## service bulletin

TO: SERVICE MANAGER | TECHNICIANS | No. 94-7

## A. STERN DRIVE - REAR ENGINE MOUNT BOLT TORQUE

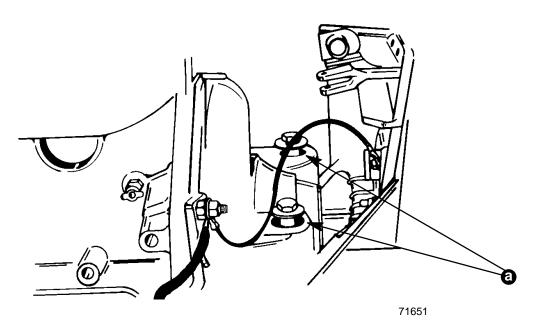
A procedure from the pre-delivery checklist is being added to the 20 hour and 100 hour/annual checklist for all MerCruiser Stern Drive Products. Effective immediately, the torque on the rear engine mounts (a) must be checked and re-torqued to the proper torque value of 35-40 lb. ft. (47-54 N.m.).

Loosen each of the rear engine mounting bolts and re-torque. Check the torque again after 10 seconds. If the torque was not retained after a 10 second waiting period, remove the rear engine mount bolt(s) and check for stripped threads on the bolt and nut. If the bolt and nut are undamaged, check the inner transom plate for cracks or damage in the area near where the captive locknut for the rear engine mount(s) seats.

If the threads on either the bolt or nut are damaged, replace the bolt and nut. If the inner transom plate shows cracks or damage in the area where the captive locknut seats, replace the inner transom plate. Before replacing an inner transom plate, call your MerCruiser Technical Assistance Department for pre-approval.
